LOWER & MAIN LEVEL AUDITORIUM RENOVATION ALTERNATES

2024-06-13 Issued for 95% CD Client Review 2024-07-03 Issued for Bid and Building Permit 2024-07-29 Issued for Addendum 3

WSU - DeRoy Building Renovations

Drawing Title **CONTEXT MAP, DRAWING** LISTS, LIST OF **ALTERNATES**

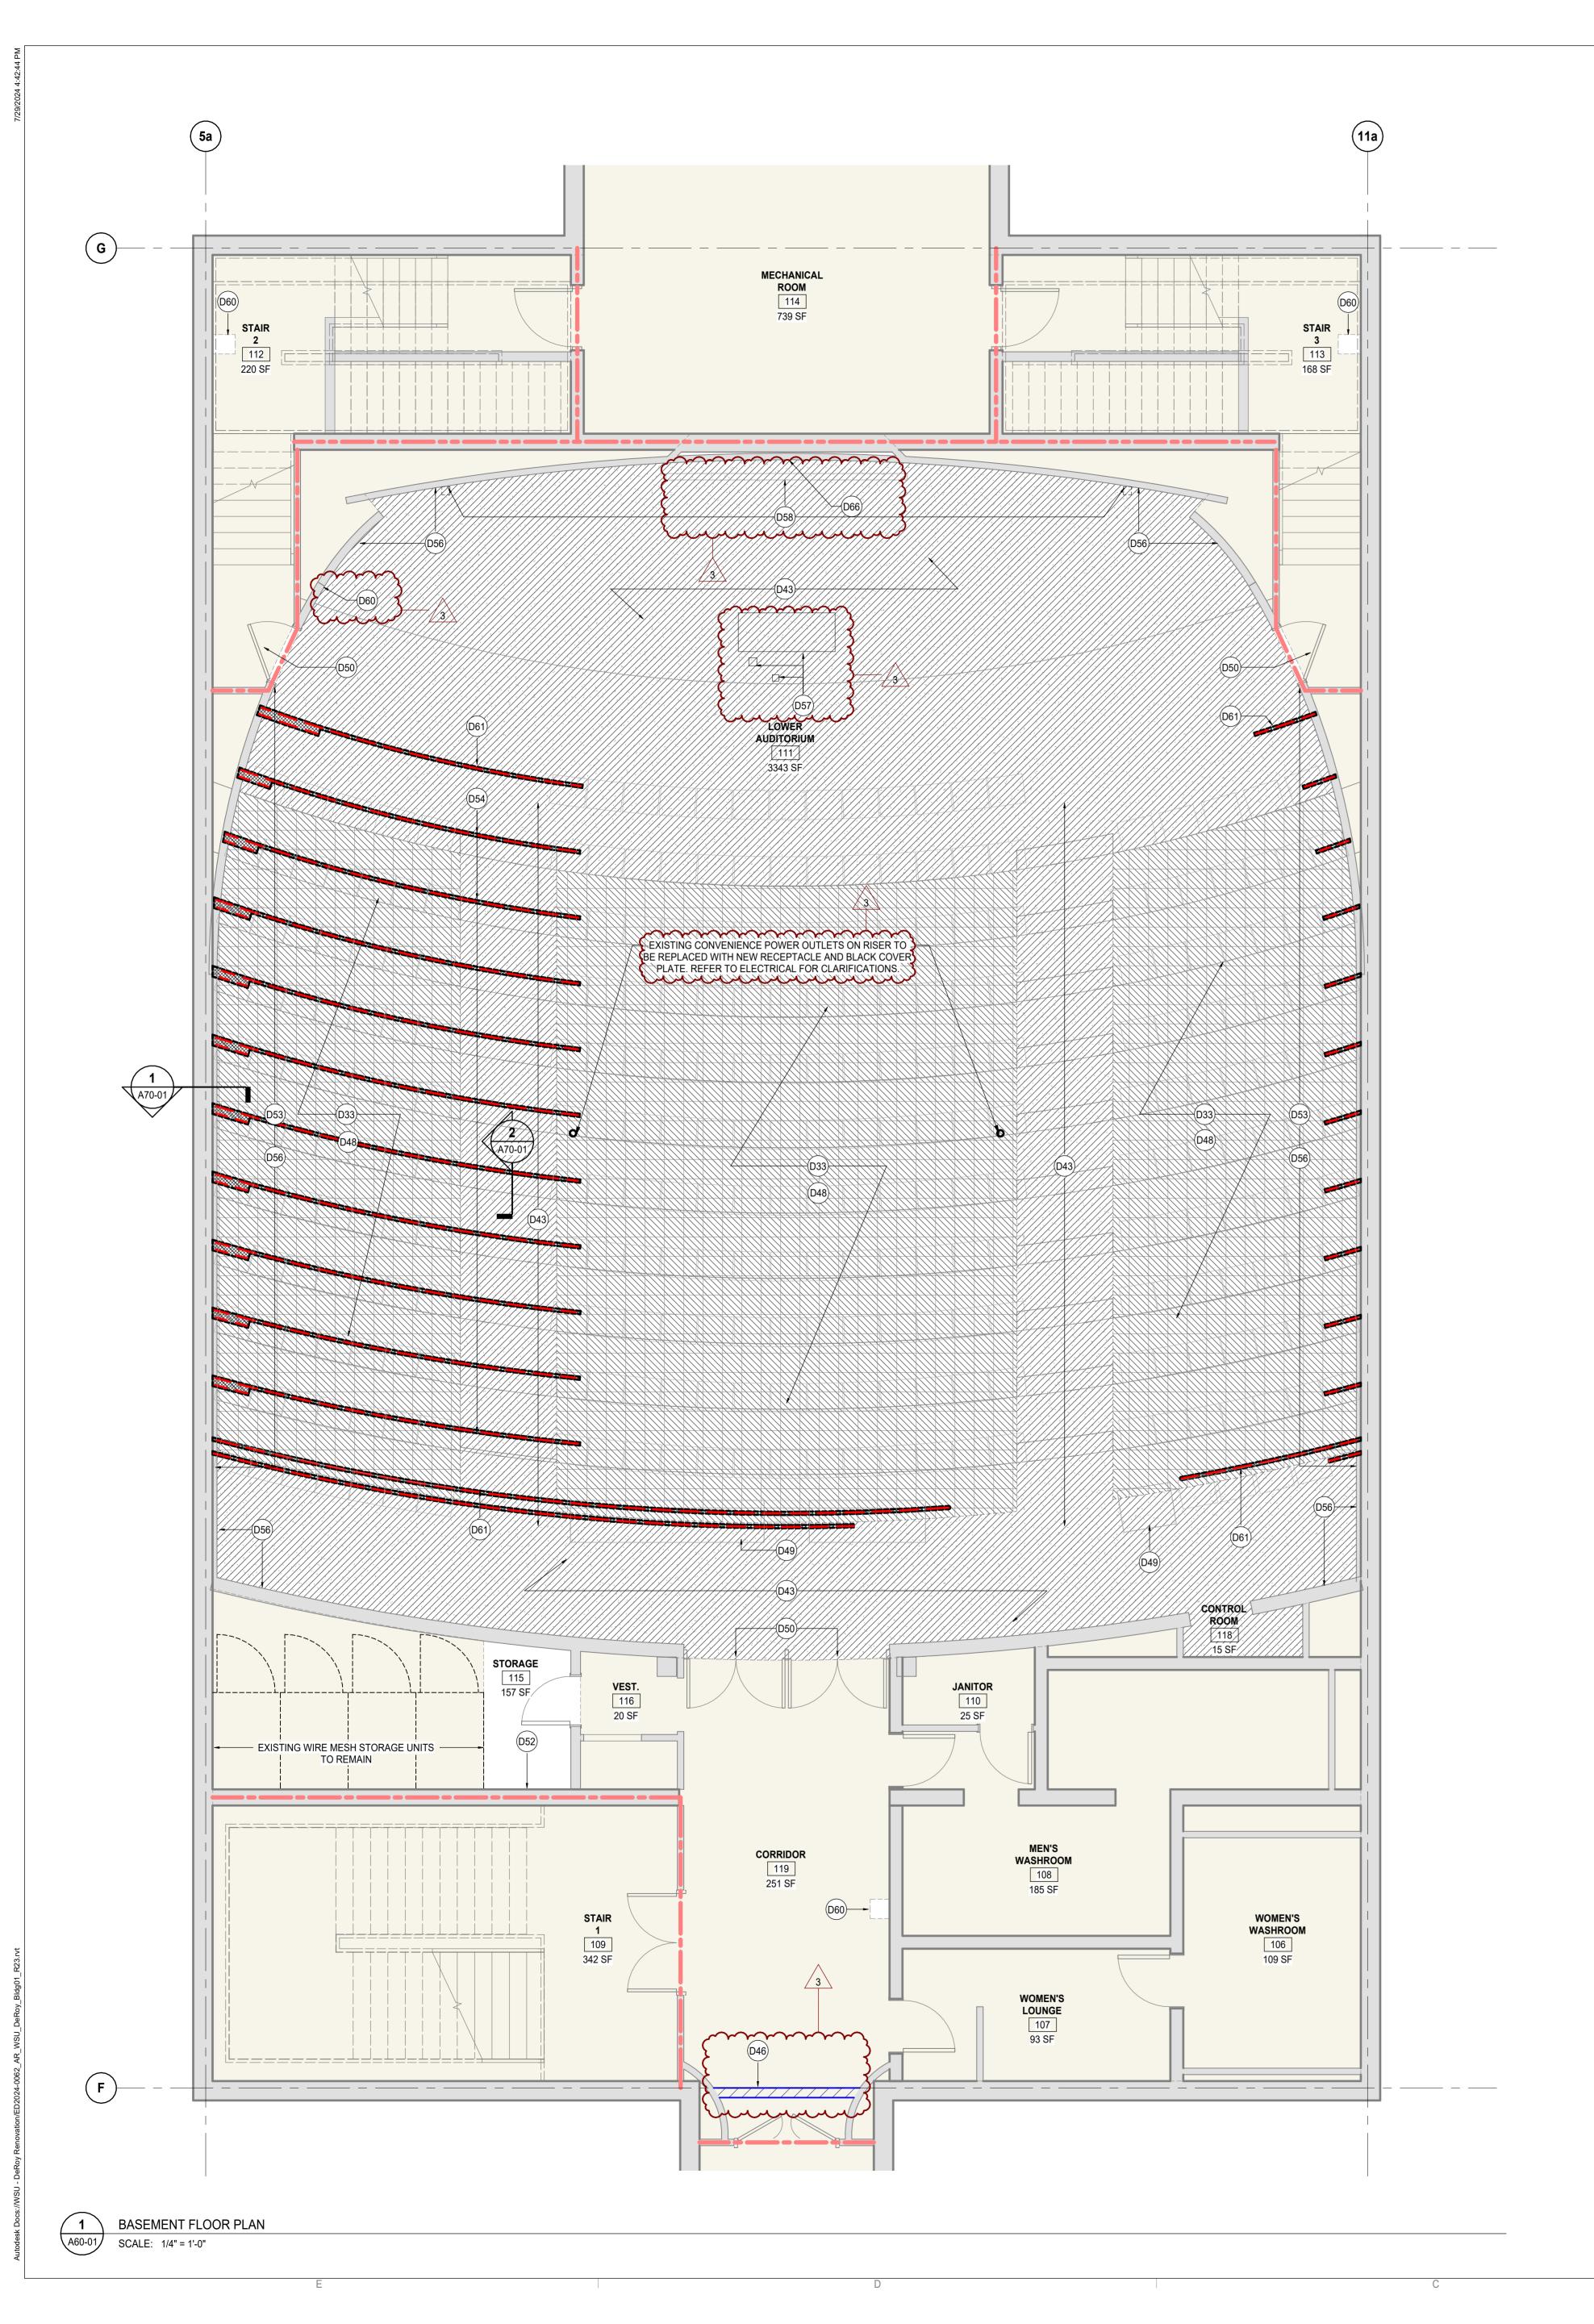
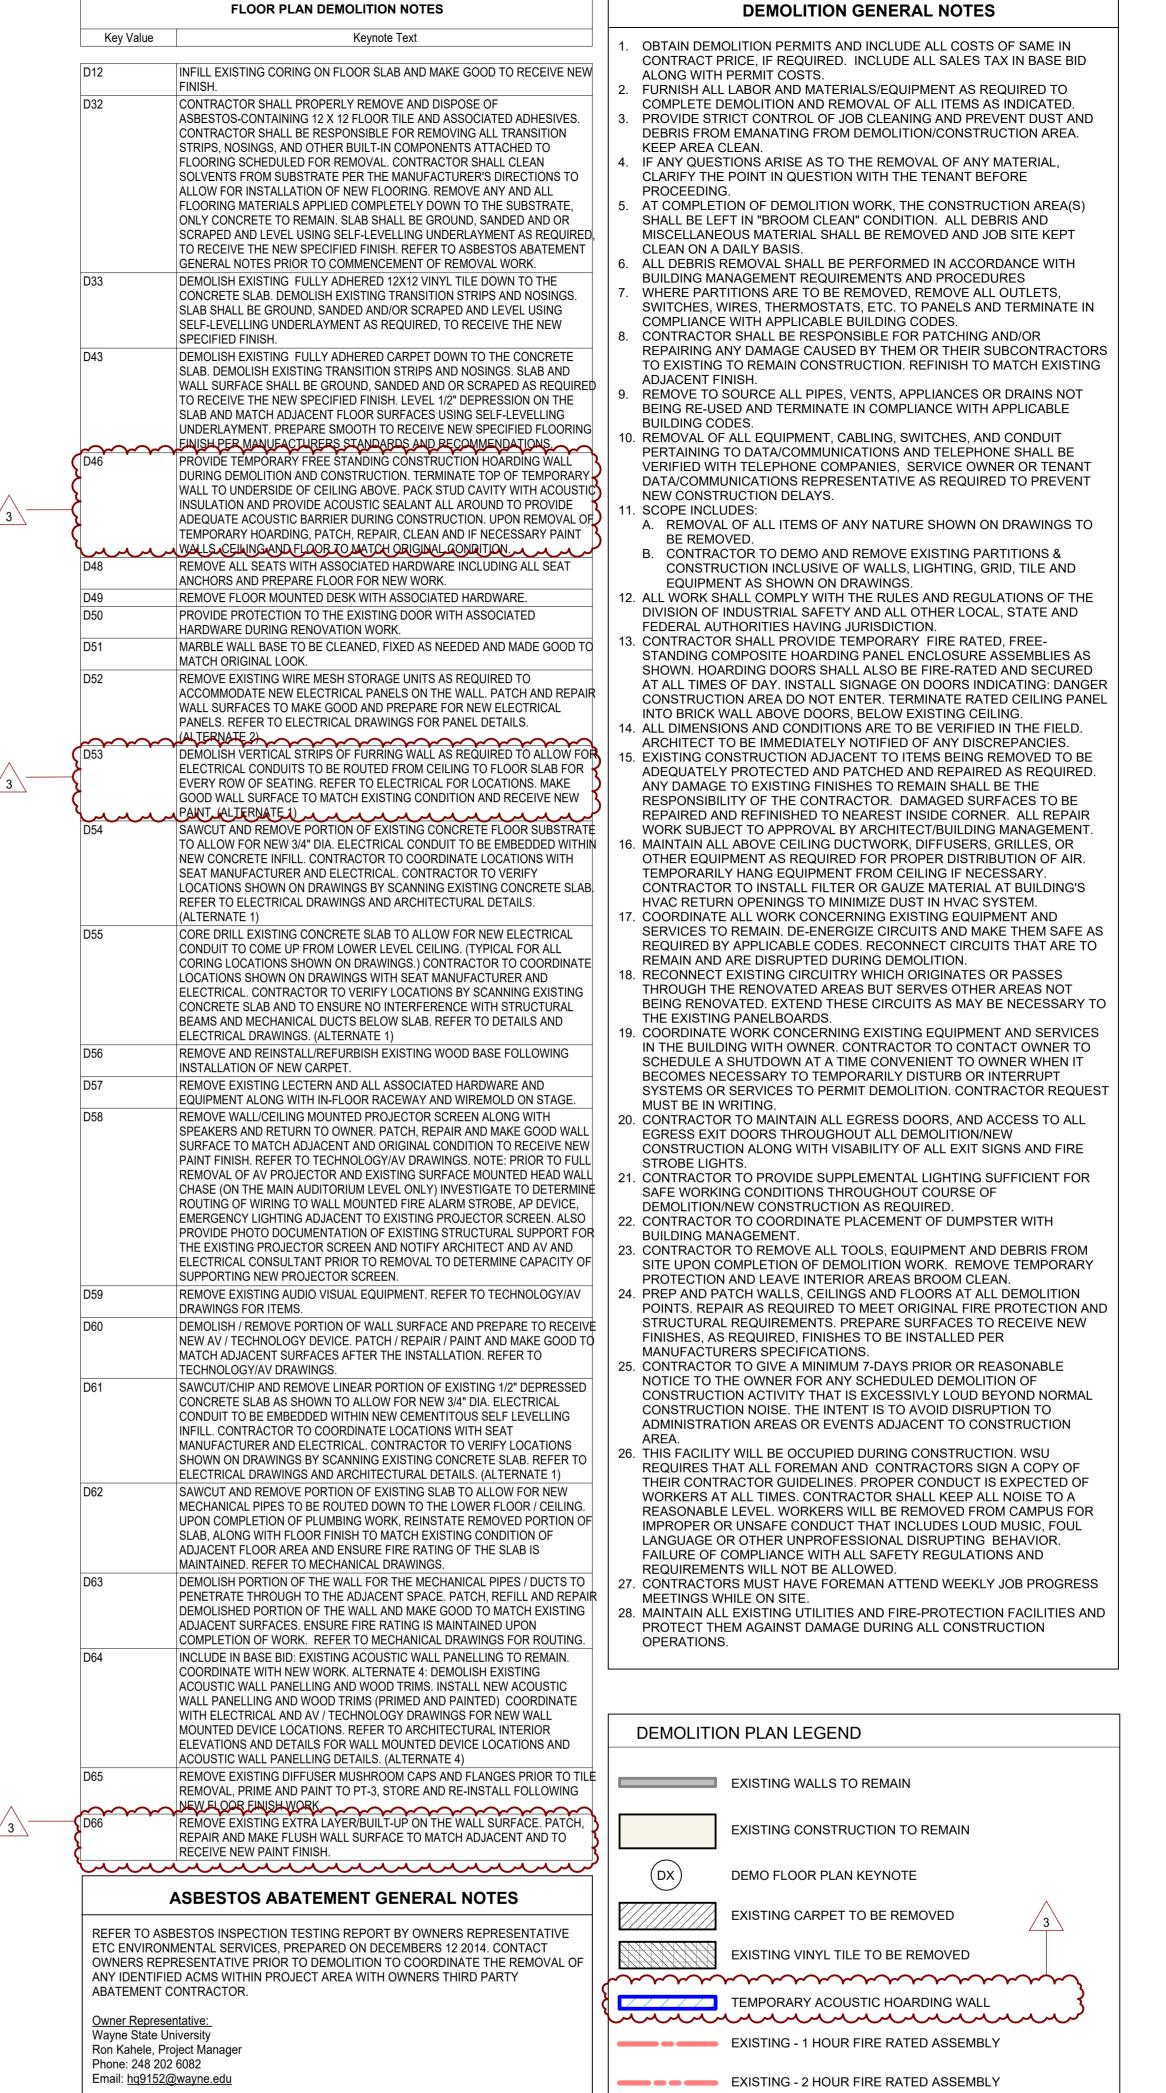
ALTERNATE #1: LOWER AND MAIN LEVEL AUDITORIUM: ANCILLARY WORK RELATED TO ELECTRIFICATION OF NEW FIXED SEATING AND NEW ELECTRICAL PANELS.

ADD: DEMOLITION: REMOVE THE EXISTING PLASTER CEILING IN THE LOWER-LEVEL AUDITORIUM TO RUN CONDUITS TO FIXED SEATING, CREATE POKE-THROUGHS AT THE MAIN LEVEL FLOOR SLAB AND TO RUN CONDUITS FROM MAIN INFEED PANEL TO THE NEW PANEL LOCATIONS IN STORAGE ROOM PANELS A1 AND A2 AS INDICATED ON DRAWING SHEETS A10-03 / A20-06 / A70-01 / E10-01. NEW WORK: PATCH AND REPAIR THE PLASTER CEILING IN THE LOWER-LEVEL AUDITORIUM TO MAKE

ADD: DEMOLITION: REMOVE EXISTING PLASTER FURRING WALL ON THE NORTH AND SOUTH WALLS AT LOWER LEVEL TO RUN CONDUITS TO THE NEW FIXED SEATING AS INDICATED ON DRAWING SHEET A10-01. NEW WORK: PATCH AND REPAIR PLASTER NORTH AND SOUTH WALLS AFTER RUNNING CONDUITS TO THE NEW FIXED SEATING AT LOWER LEVEL AS INDICATED ON DRAWING SHEET A10-01.

ADD: DEMOLITION: CHIP & REMOVE EXISTING CONCRETE FLOOR SUBSTRATE FOR INSTALLATION OF NEW 3/4" DIAMETER EMBEDDED CONDUIT ON LOWER LEVEL AS INDICATED ON DRAWING SHEETS A10-01 / A20-06 / A70-01. NEW WORK: INFILL CONCRETE AT ELECTRICAL CONDUIT ROUTING LOCATIONS ON LOWER LEVEL AUDITORIUM AS INDICATED ON DRAWING SHEETS A10-01 / A20-06 / A70-01.

ADD: ELECTRICAL JUNCTION BOXES AND EMPTY CONDUITS WITH PULL STRINGS LOCATED IN WALLS AND CEILING FOR ELECTRIFICATION OF NEW SEATING AT LOWER-LEVEL AUDITORIUM AS INDICATED ON DRAWING SHEETS A10-01 / A10-03 / A20-06 / A60-01 / A70-01 / E10-01

ADD: CORING (POKE-THROUGHS) OF THE EXISTING MAIN LEVEL AUDITORIUM CONCRETE FLOOR SLAB FOR

ADD: ELECTRICAL JUNCTION BOXES AND EMPTY CONDUITS WITH PULL STRINGS ABOVE LOWER LEVEL AUDITORIUM CEILING FOR ELECTRIFICATION OF NEW SEATING AT MAIN-LEVEL AUDITORIUM AS INDICATED ON DRAWING SHEET A10-03 / E10-01.

ADD: ELECTRICAL JUNCTION BOXES AND EMPTY CONDUITS WITH PULL STRINGS ABOVE LOWER LEVEL AUDITORIUM CEILING FROM MAIN INFEED PANEL TO THE NEW PANEL LOCATIONS IN STORAGE ROOM PANELS A1 AND A2 FOR ELECTRIFICATION OF NEW SEATING AT MAIN-LEVEL AUDITORIUM AS INDICATED ON DRAWING SHEET

ADD: PROVIDE POWER, ELECTRICAL PANELS, WIRING AND FINAL POWER CONNECTIONS FOR THE ELECTRIFICATION OF NEW FIXED SEATING ON BOTH AUDITORIUMS AS INDICATED ON DRAWING SHEET E10-01. MUST INCLUDE ALTERNATE #1 IN ALTERNATE PRICE #2.

ALTERNATE #3: LOWER LEVEL AUDITORIUM: ACOUSTIC WALL PANELING AT NORTH AND SOUTH WALLS

BASE BID: PATCH AND REPAIR THE EXISTING PLASTER. PRIME AND PAINT THE ENTIRE NORTH, SOUTH, AND WEST WALLS AS INDICATED ON DRAWING SHEETS A20-04 / A60-01.

ADD: INSTALL NEW ACOUSTIC WALL PANELLING WOOD ENCLOSURE TRIM ON 2 1/2" METAL STUD FURRING WITH 2" THICK (ROCKWOOL) ACOUSTIC ABSORBER INSULATION AS INDICATED ON THE DRAWING SHEET A60-02. COORDINATE WITH AV AND ELECTRICAL DRAWINGS FOR THE LOCATIONS OF NEW DEVICES AND ROUTING OF

ALTERNATE #4: MAIN LEVEL AUDITORIUM: ACOUSTIC WALL PANELING AT NORTH, SOUTH AND EAST WALLS BASE BID: EXISTING ACOUSTIC WALL PANELING ON NORTH, SOUTH, AND EAST WALLS WILL REMAIN. PRIME AND PAINT EXISTING ACOUSTIC WALL PANELING, AND COORDINATE WITH AV AND ELECTRICAL DRAWINGS FOR THE

ADD: DEMOLITION: EXISTING ACOUSTIC WALL PANELING AND WOOD TRIMS AS INDICATED ON DRAWING NEW WORK: INSTALL NEW ACOUSTIC WALL PANELING AND WOOD TRIM (PRIMED AND PAINTED) ON

THE NORTH, SOUTH, AND EAST WALLS AS INDICATED ON DRAWING SHEETS A10-02 / A60-02 / A70-01. COORDINATE WITH AV AND ELECTRICAL DRAWINGS FOR THE LOCATIONS OF NEW DEVICES AND ROUTING OF WIRING AS INDICATED ON DRAWING SHEETS A60-01/ A60-02 / T20-02.

T20-02

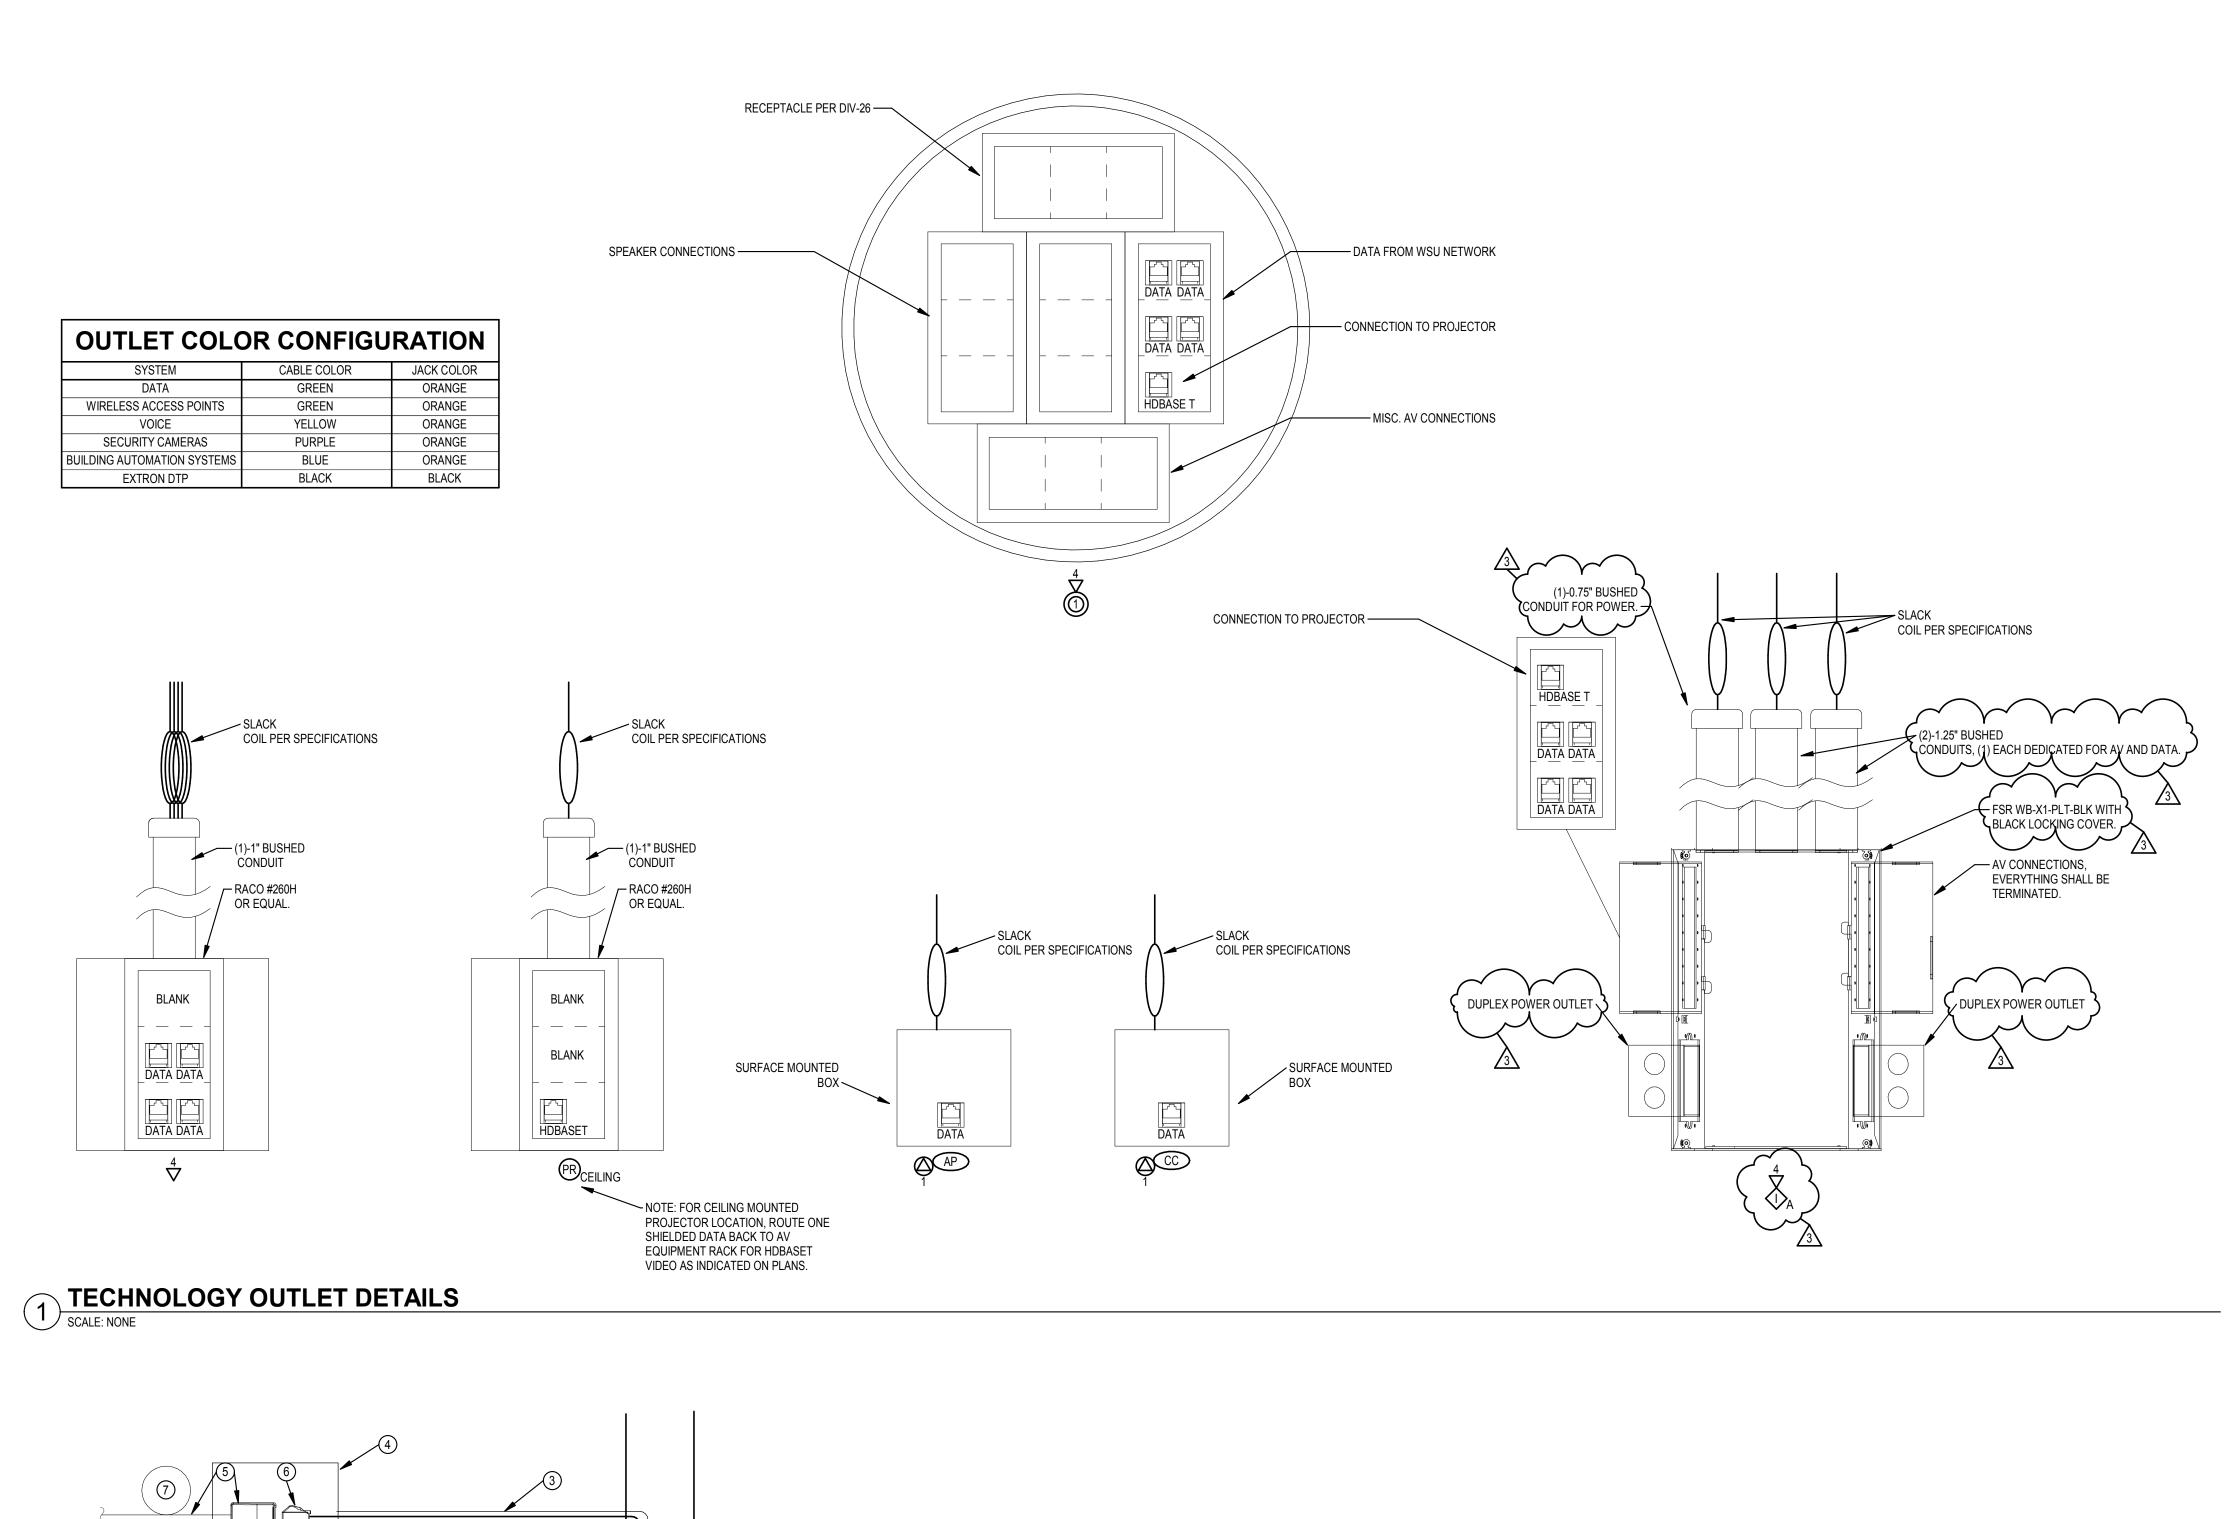
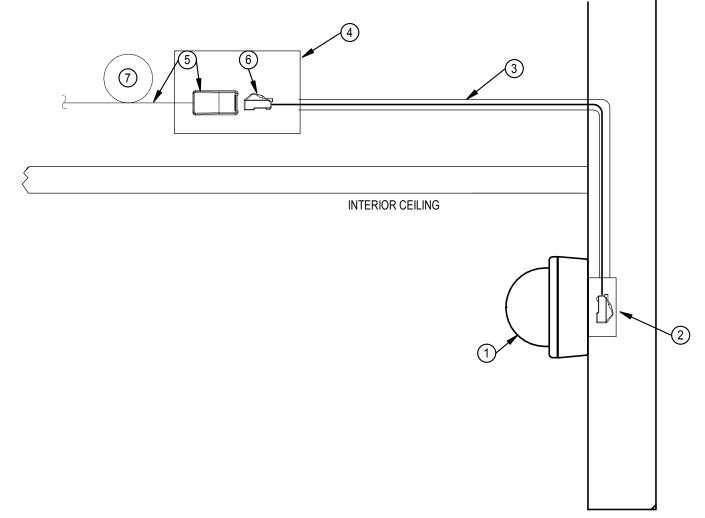
- 9. BASE BID: PROVIDE SURFACE RACEWAY ABOVE EXISTING MARBLE FEATURE AND BELOW EXISTING ACOUSTIC PANELING, AND ROUTE UP IN VERTICAL RACEWAY TO SERVE AP LOCATIONS. RACEWAY SHALL BE PRIME AND FINISH PAINTED. COORDINATE EXACT LOCATION WITH ARCHITECTURAL ELEVATIONS.

- ALTERNATE #4: ELIMINATE VERTICAL RACEWAY SECTION AND ROUTE CABLING UP THROUGH CENTER OF ACOUSTIC WALL PANEL FROM HORIZONTAL RACEWAY. CUT AND MOUNT AP IN CENTER OF PANEL. COORDINATE EXACT LOCATION WITH ARCHITECTURAL ELEVATIONS.
